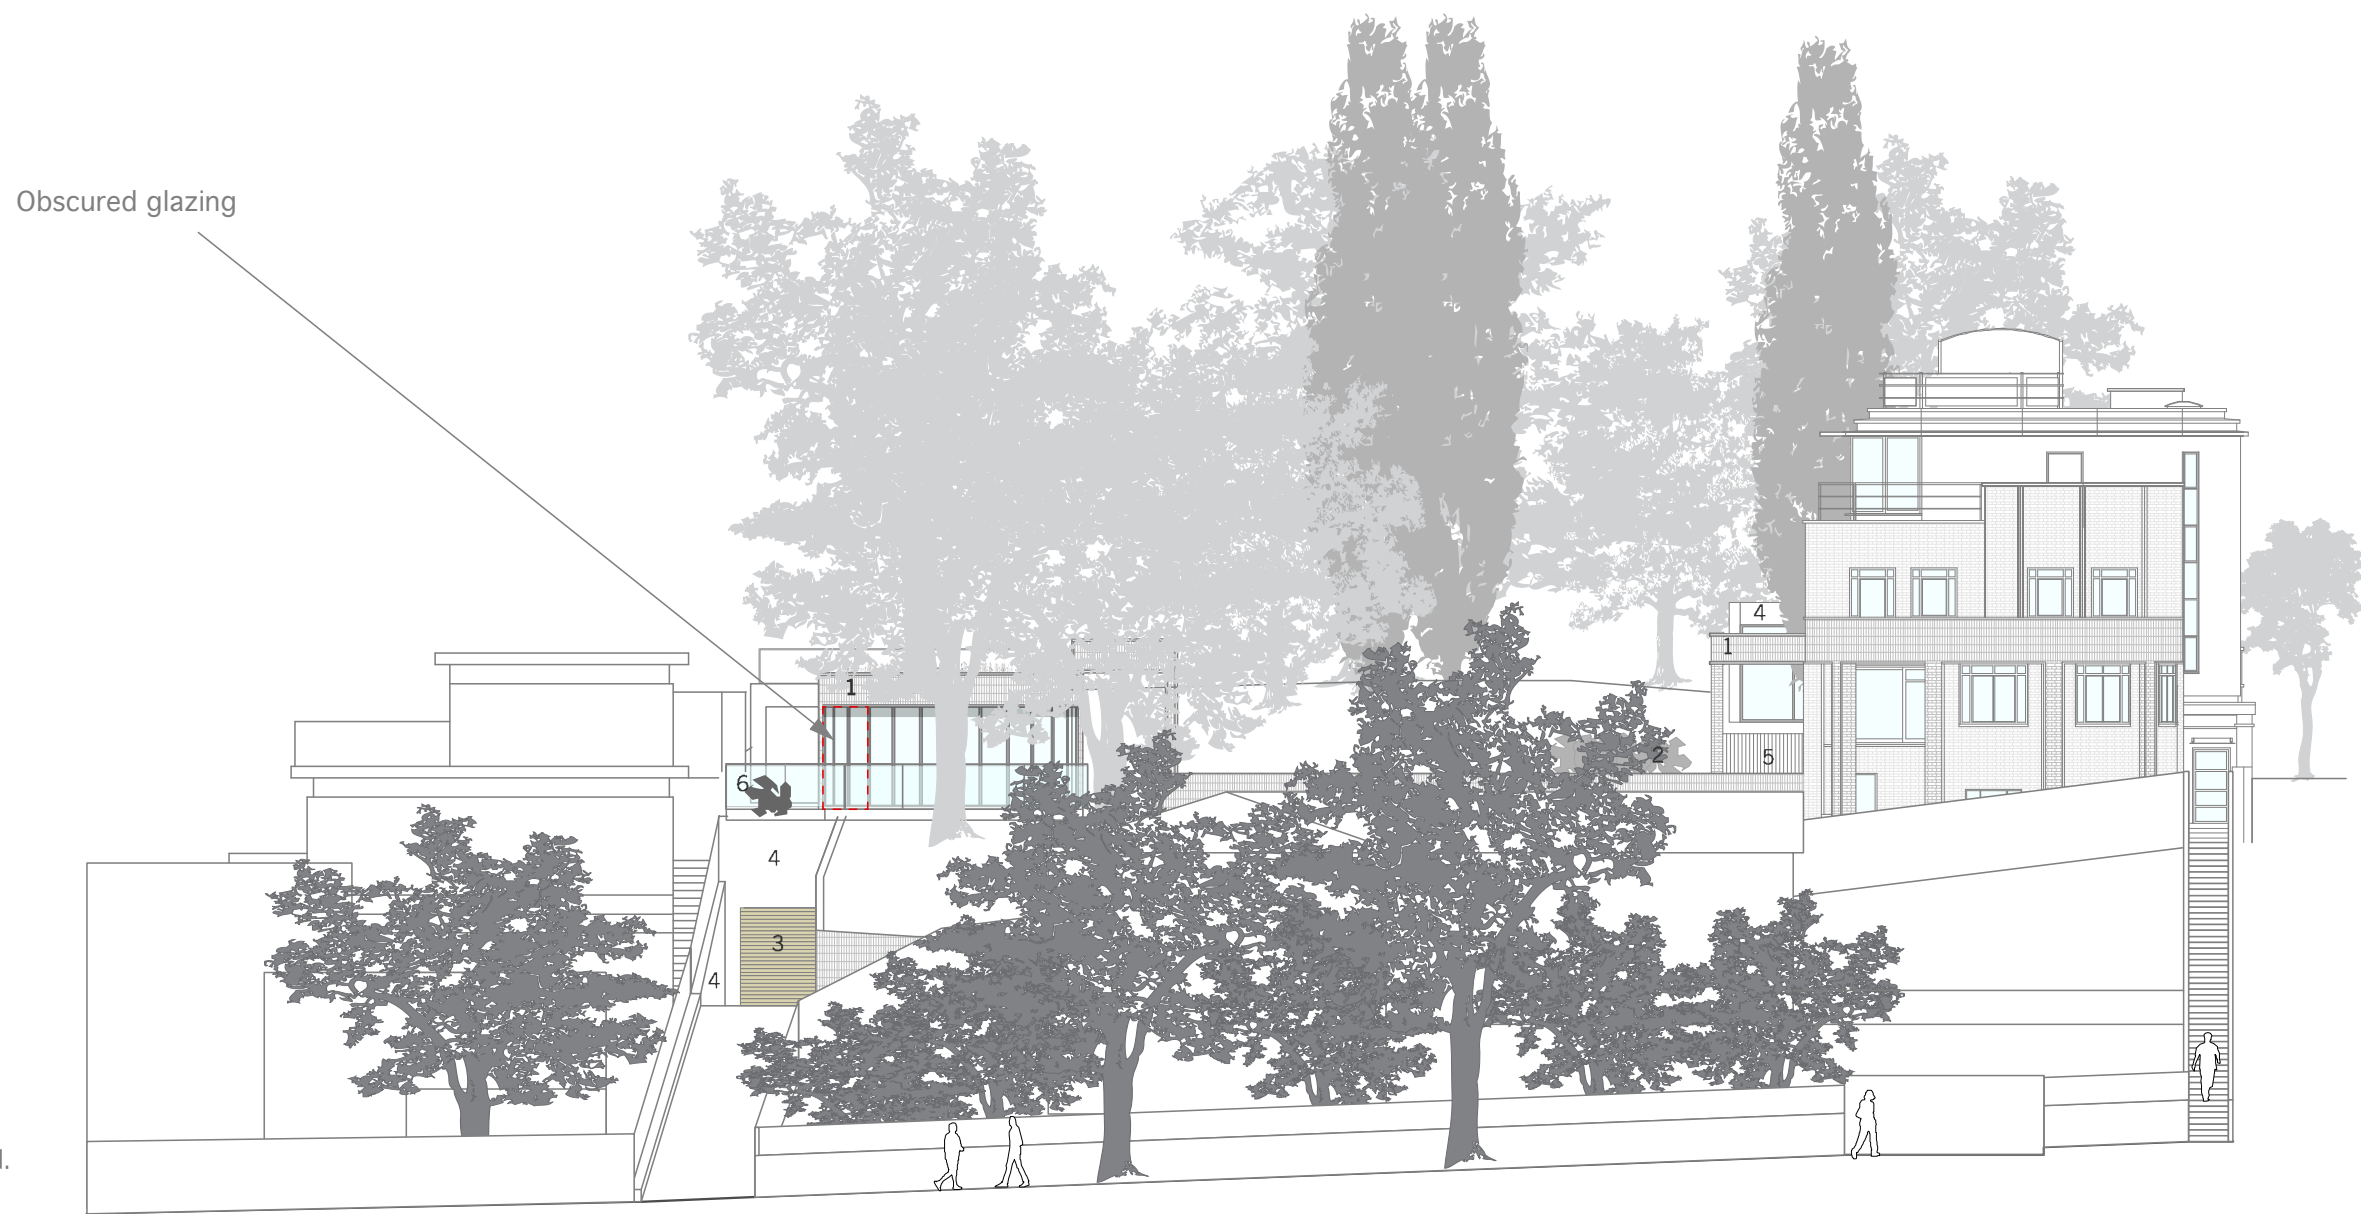
Outline of proposed extension revised.

Materials to entrance of car park indicated.

Dining room reduced north by 500 mm.

Non-accessible low level planter added to south of annex.

1.2m glazed screens added to prevent access and overlooking.

1/3 of library window specified obscured glass and non-openable.

Planters and guarding added to roof of annex at rear.

Outline of proposed extension revised.

Dining room reduced north by 500mm.

Kitchen moved north.

Site fence of north boundary to 89 Redington Road indicated.

Planters and guarding added to roof of annex to make it non-accessible.

Picture window added to west elevation of rear extension.

Context of 85A added to drawing.

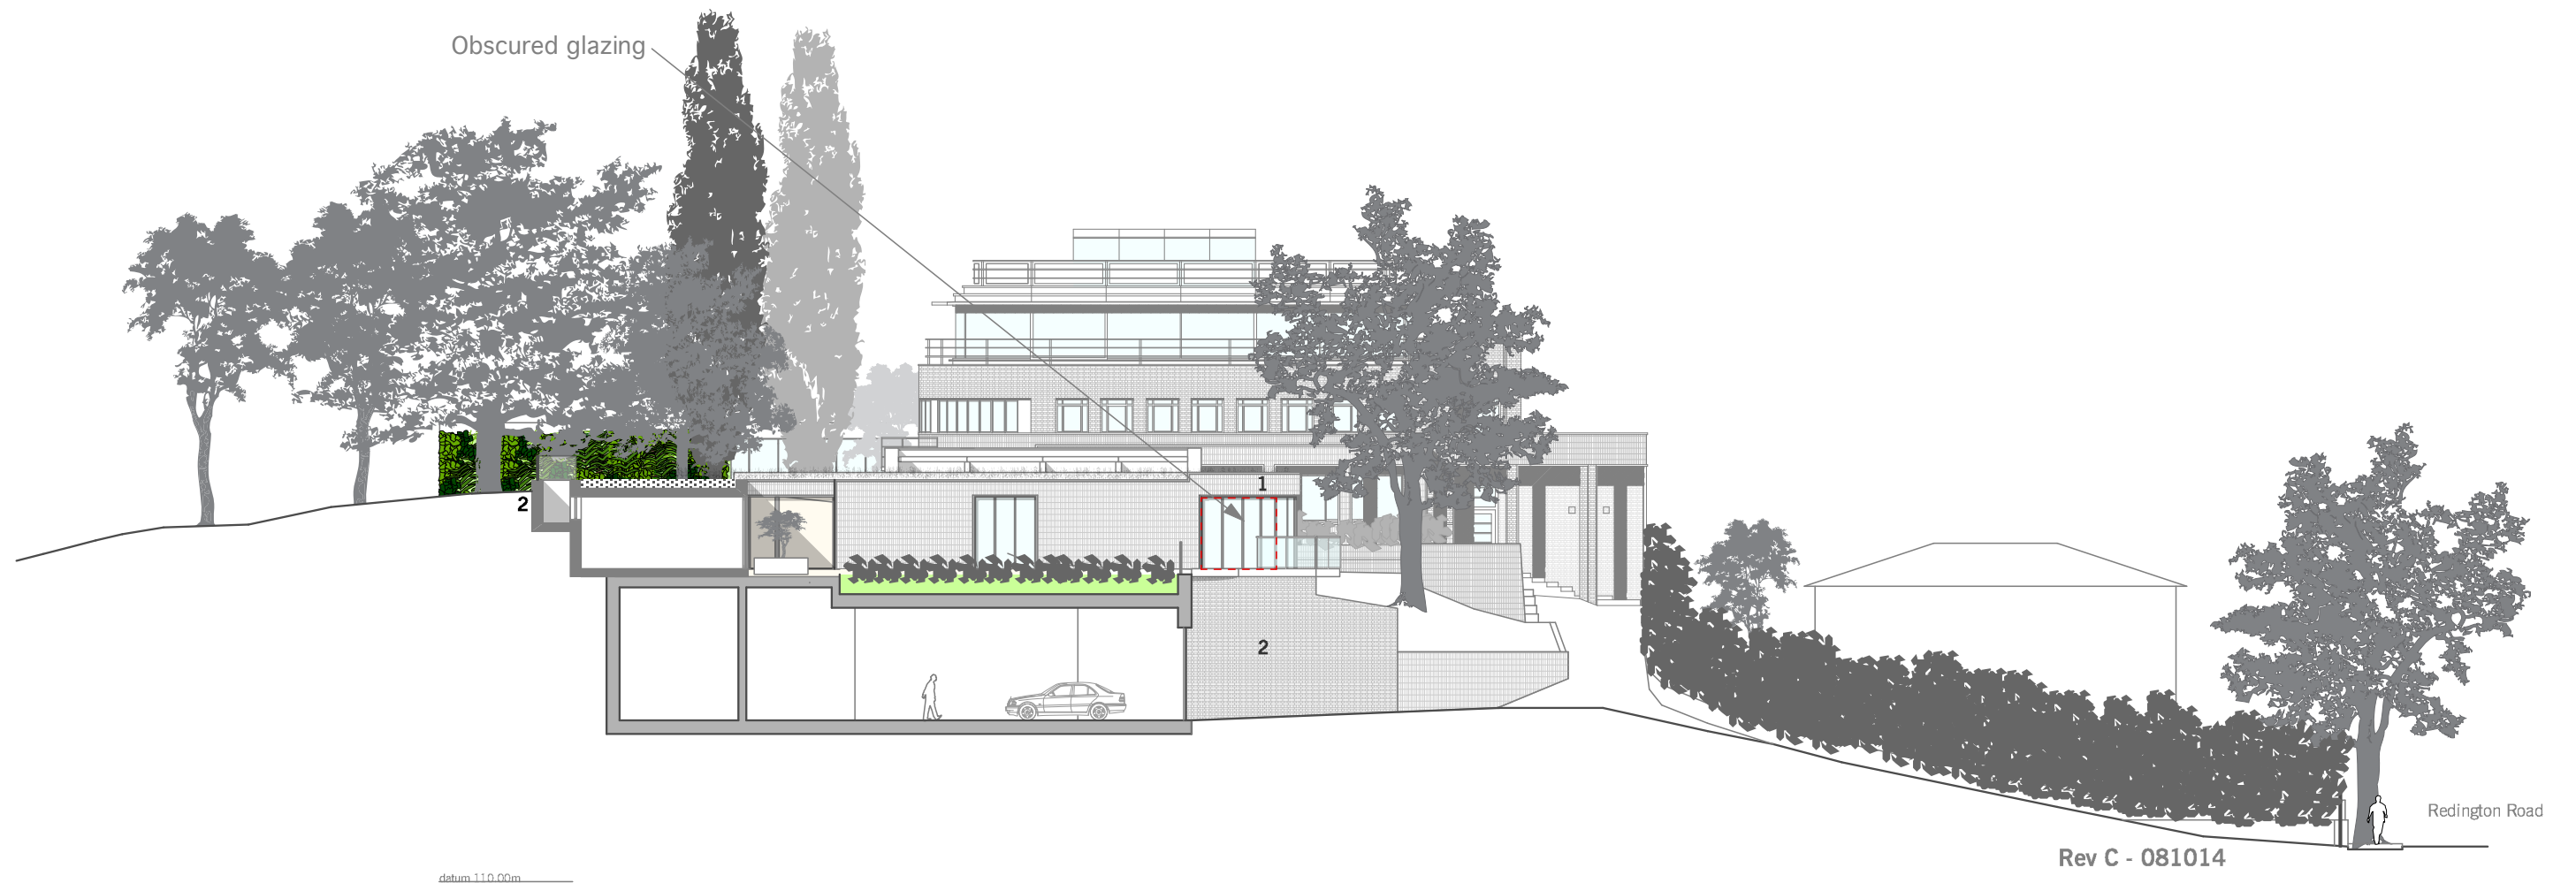
Outline of proposed extension revised.

Basement level lowered.

Non-accessible low level planter added to south of annex.

1.2m glazed screens added to prevent access and overlooking.

1/3 of library window specified obscured glass and non-openable.

Planters and guarding added to roof of annex at rear.

Outline of proposed extension revised.

South extension cut back to protect root ball of oak T11.

Planters and guarding added to roof of annex to make it non-accessible.
